STAFF REPORT
ETHAN COURT
SUBDIVISION S 2-23
JULY 7, 2023

Subject: ENGINEERING COMMENTS FOR S 2-23 PRELIMINARY PLAT “ETHAN COURT” SUBDIVISION

PRELIMINARY SUBDIVISION
 ETHAN COURT
 TAX MAP 20-03-33-23 TAX LOT 2000
 COTTAGE GROVE, OREGON
 10 MAY, 2023

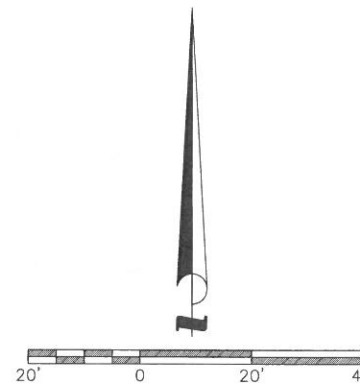
The applicant proposes to provide access to the parcels through one shared driveway that is approximately 25' wide, and therefore, there are no additional streets, sidewalks, bicycle lanes, or pathways proposed. The applicant did not provide plans for utilities, and therefore, it shall be a condition of approval before final plat submission to detail the locations of such.

The applicant proposed a hammer-head style access to the parcels on the west end of the parcel. The hammer-head must adhere to Fire Department Standards. This turnaround shall also meet requirements of Section 14.34.100 Transportation Standards G 1. This shall be a condition of approval.

The applicant proposed to demolish the existing carport/garage on site, but keep the existing single family dwelling. On the application, it appears there is approximately 3ft between the north side of Lot 1 and the existing residence. With the division of Lot 1 (with the existing single family dwelling), setbacks will need to be adhered to on the final plat, and shall be a condition of approval.

10. Details for locations of utilities must be submitted prior to final plat recordation.
11. The proposed hammer-head style access to the parcels must adhere to Fire Department Standards, as well as Section 14.34.100 Transportation Standards (G)(1).

12. Setbacks must be demonstrated on the final plat.
13. A reciprocal access agreement must be put in place, as required by Chapter 14.31.200(K).
14. Plans for mail boxes shall be approved by the United States Postal Service.
